**AMERICAN ELECTRIC POWER
COOK NUCLEAR PLANT
NUCLEAR GENERATION GROUP
BRIDGMAN, MICHIGAN**

Title: **Reactor Coolant System Pressure
3-inch**

UFSAR Figure: **14.3.2-22**

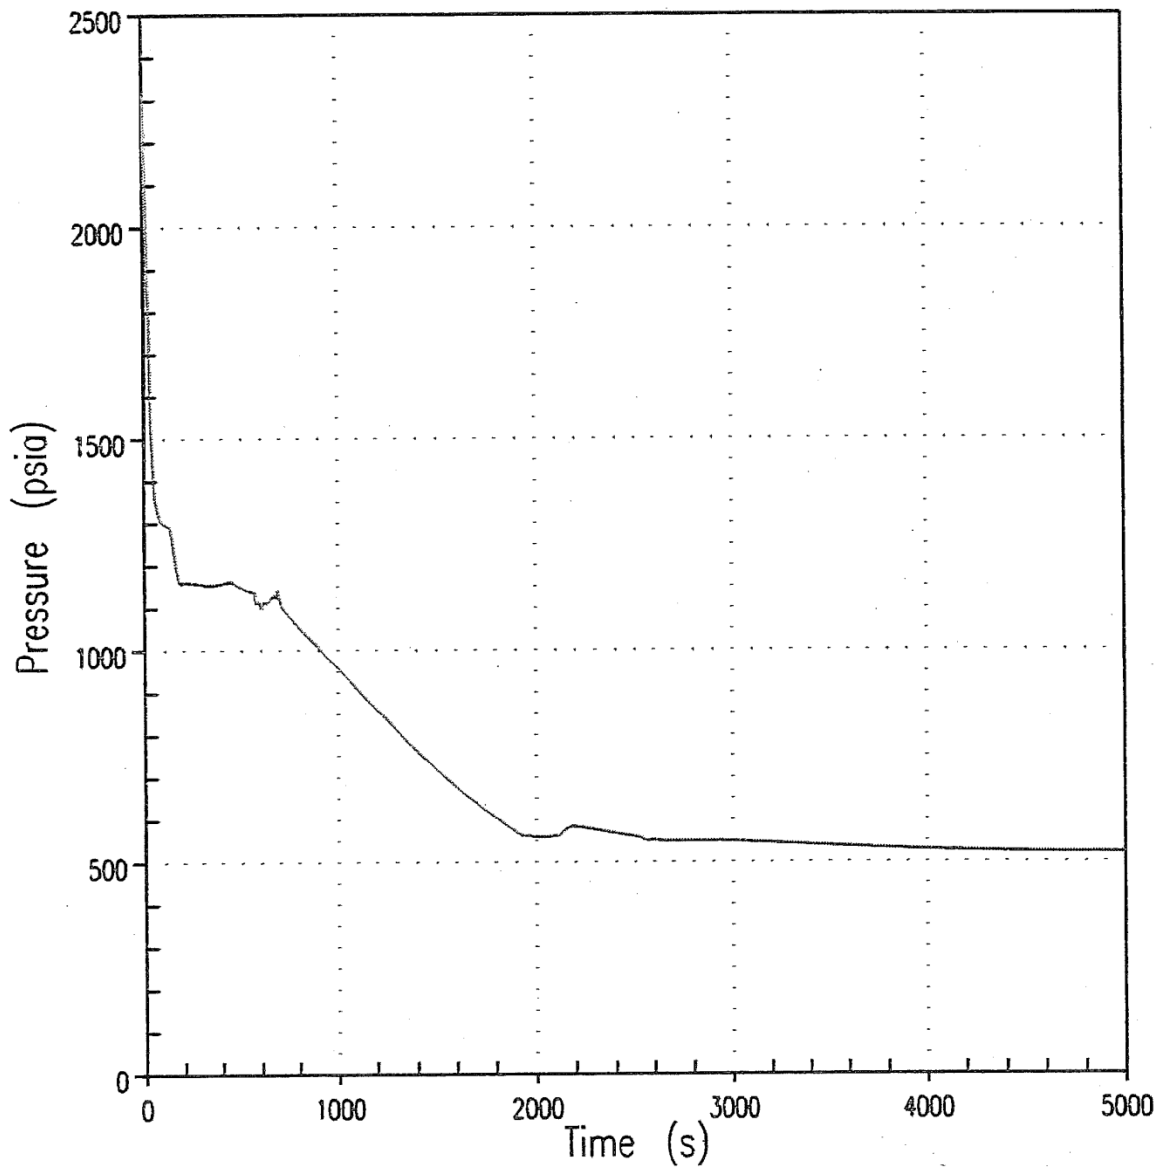
Change Description: **UCR-1966, Rev. 0**
